ARBORICULTURAL IMPACT ASSESSMENT

4 IRRUBEL RD, NEWPORT 2106

Complete Arborcare has been commissioned by Dave & Regina Mills (the property owner) to undertake an Arboricultural Impact Assessment (AIA) regarding proposed alterations & additions upon Lot A/DP 383277 No. 4 Irrubel Rd, Newport 2106

TPZ & SRZ PLAN WITH TREE PROTECTION ZONES AND STRUCTURAL ROOT ZONES SHOWN TO SCALE.
PLAN HAS BEEN OVERLAYED ON THE SITE PLAN BY PETER STUTCHBURY ARCHITECTURE (12/02/2019)

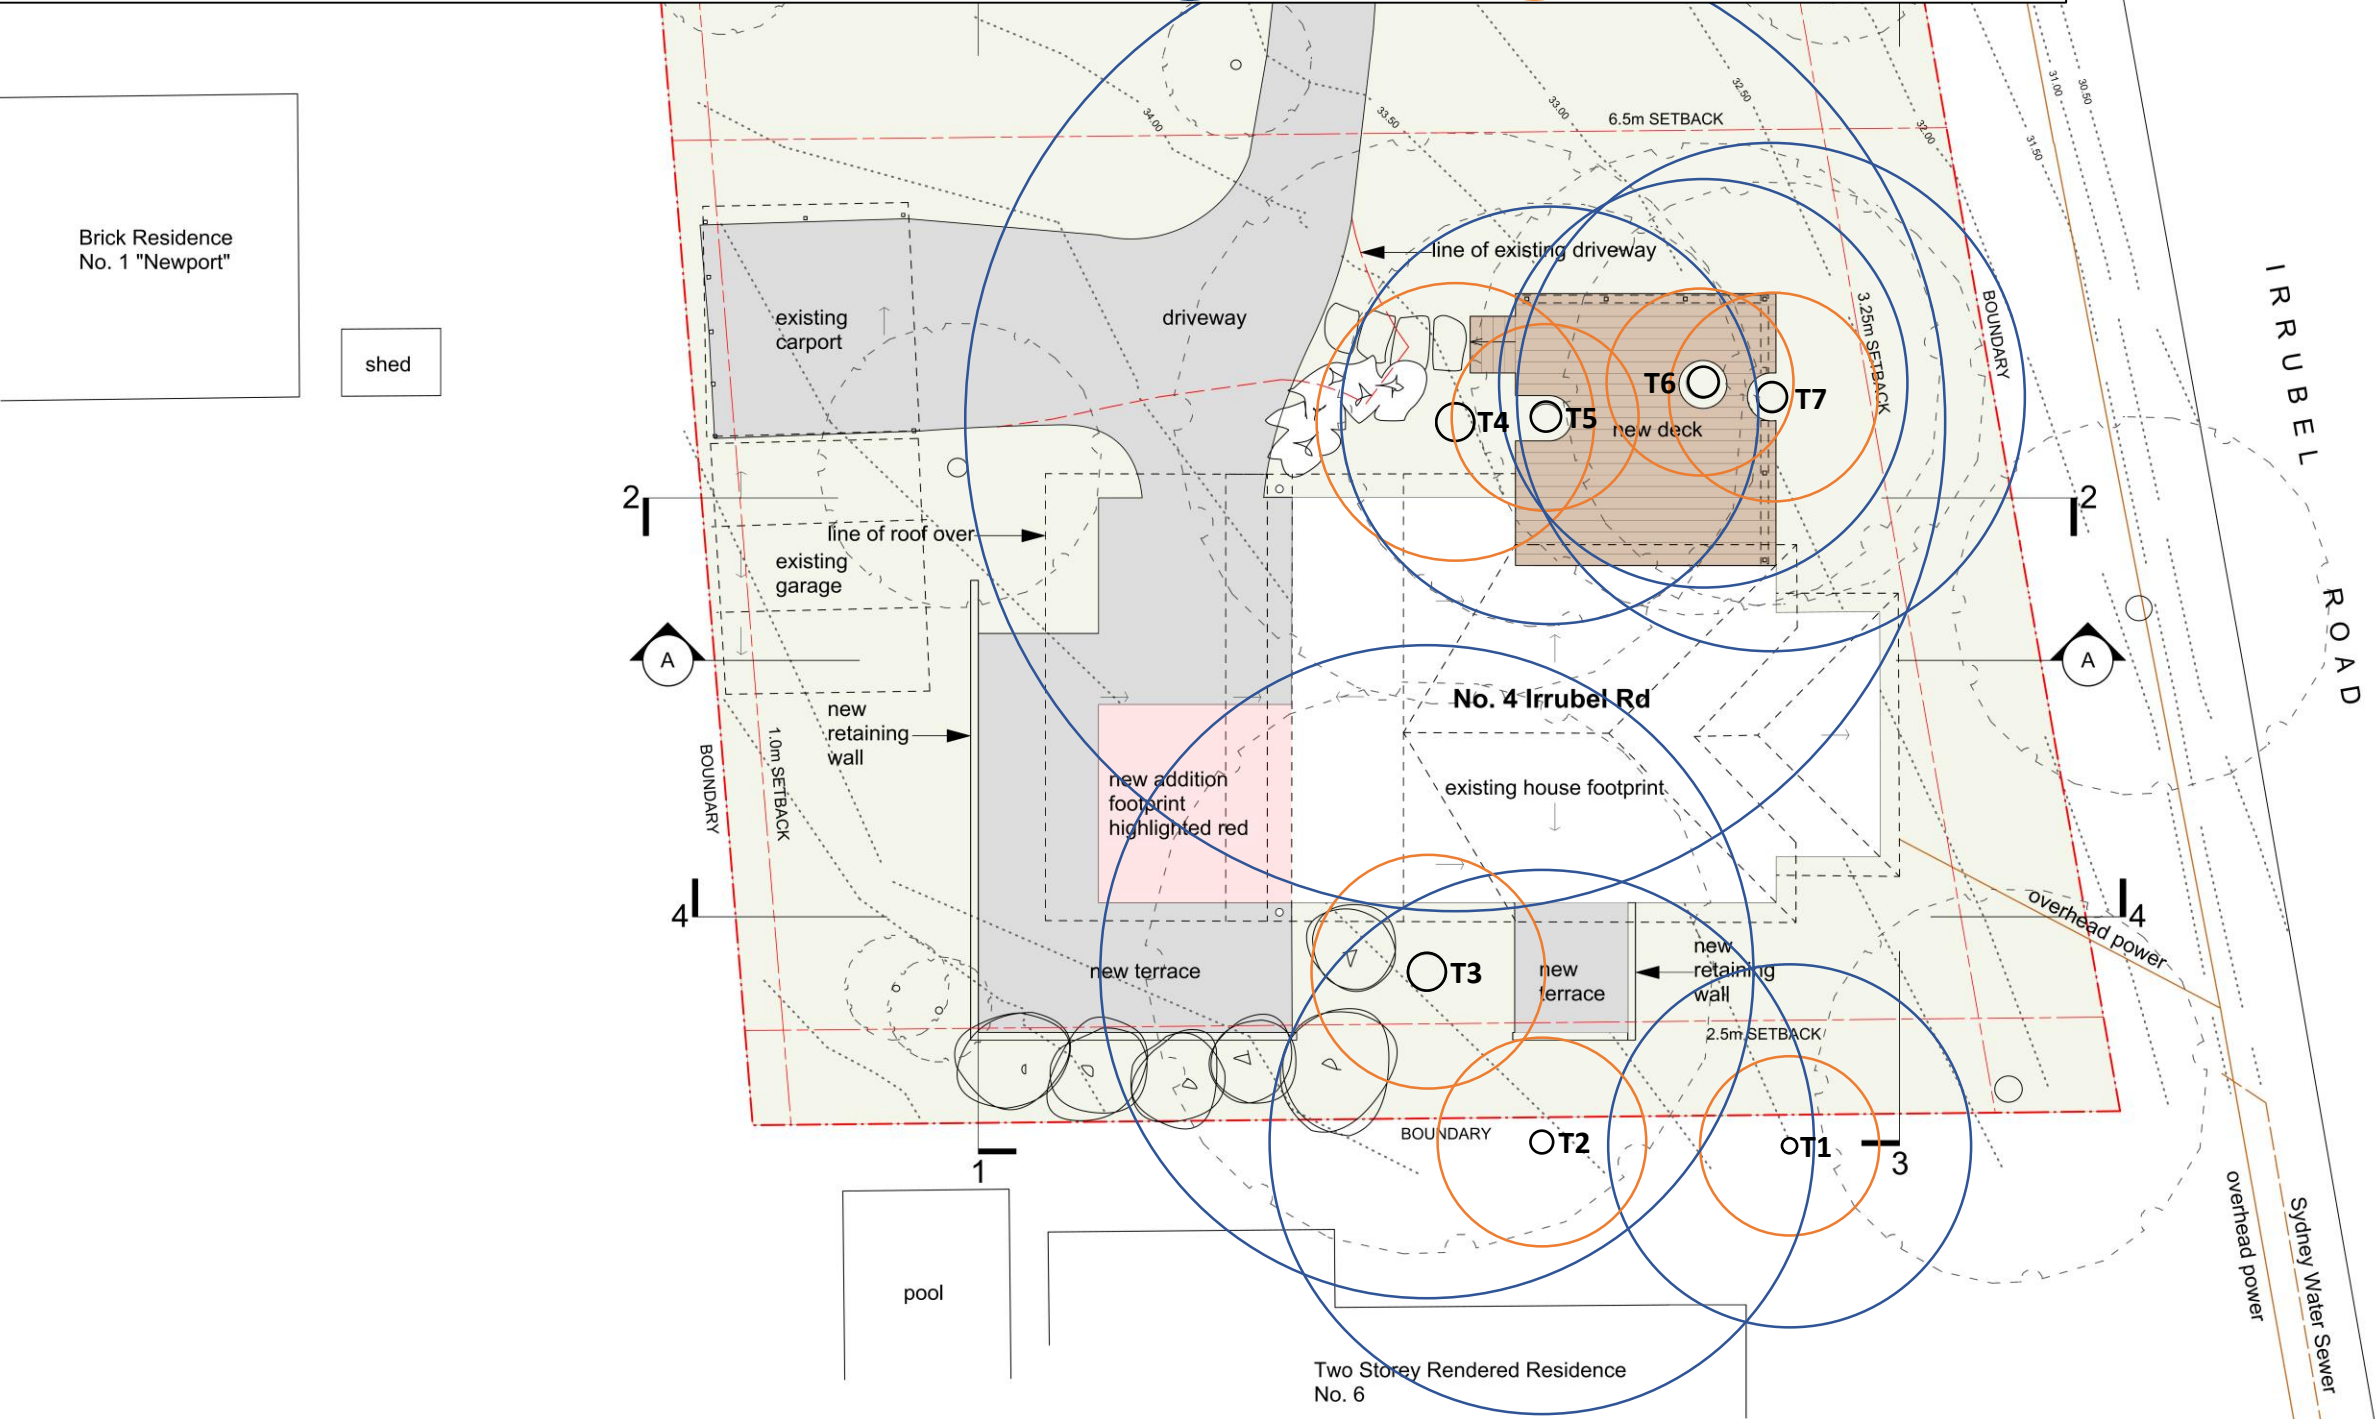
- 9.3 It is recommended that trees **T3,T4,T5,T6 & T7** have stem protection installed before any of the proposed works commence. This protection must stay in place until the completion of all works & must be compliant with clause 4.5.2 (trunk & branch protection) of AS 4970 (see appendix C, Stem Protection); activities restricted in the TPZ must be adhered by.

- 9.4 Due to trees **T3,T4,T5,T6 & T7** displaying major TPZ encroachments,the project arborist must demonstrate the subject trees will remain viable, therefore root investigations may be required as mentioned in clause 3.3.4 (a) of AS 4970-2009.If roots >50mm ø are encountered (which must be retained),relocation of footings will be required.

- 9.5 To allow for future stem expansion of trees **T5,T6 & T7**, a circular gap of at least 50mm will be required between the tree trunk and the proposed suspended deck structure.
